# Rezoning Transportation Analysis

Petition Number: 2023-134

Date	Description
11-21-23	First Review (NK)
12-20-23	Second Review (NK)

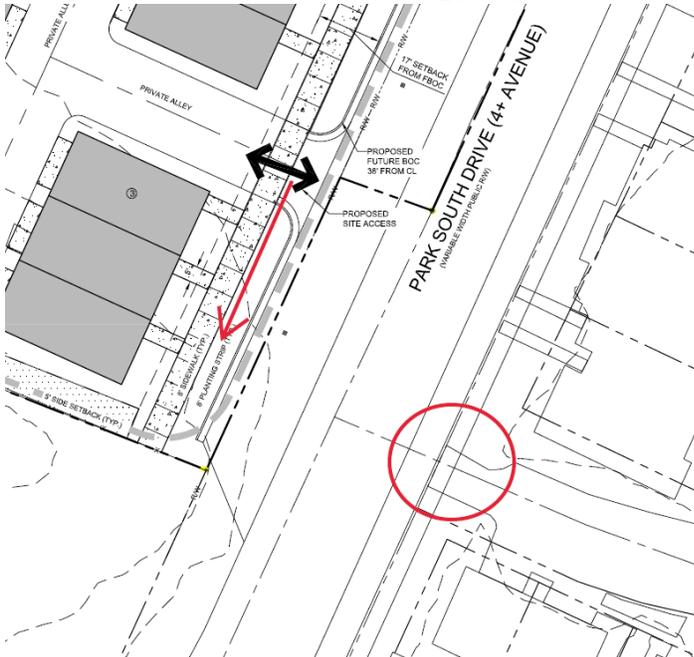
4. Revise site plan and conditional note(s) to commit to construct bicycle facilities by locating the curb and gutter 38' from the center line.

**Clarifying Comment 12/20/23:** Dimension for proposed BOC to CL needs to be shown on the plans as well as the buffered bike lane that is required per the Charlotte Street Map cross section.

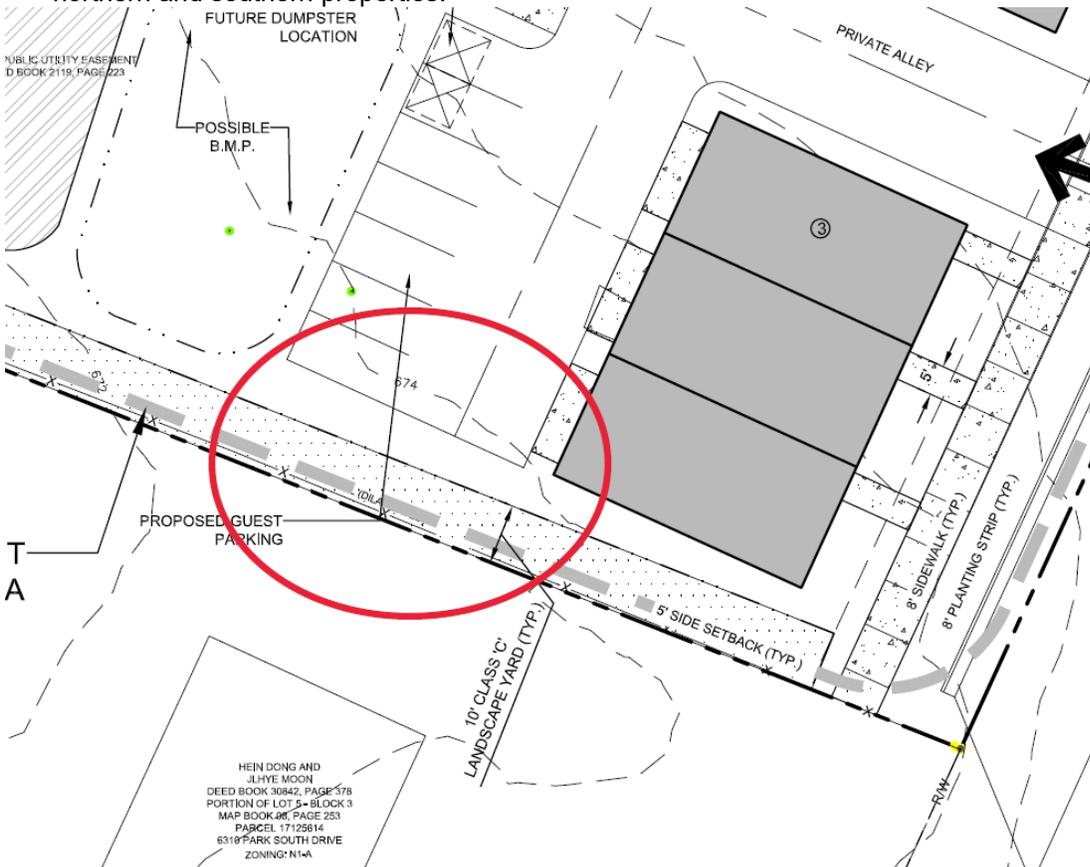
~~5. Revise site plan and conditional note(s) to commit to aligning driveway with the driveway located on the opposite property~~
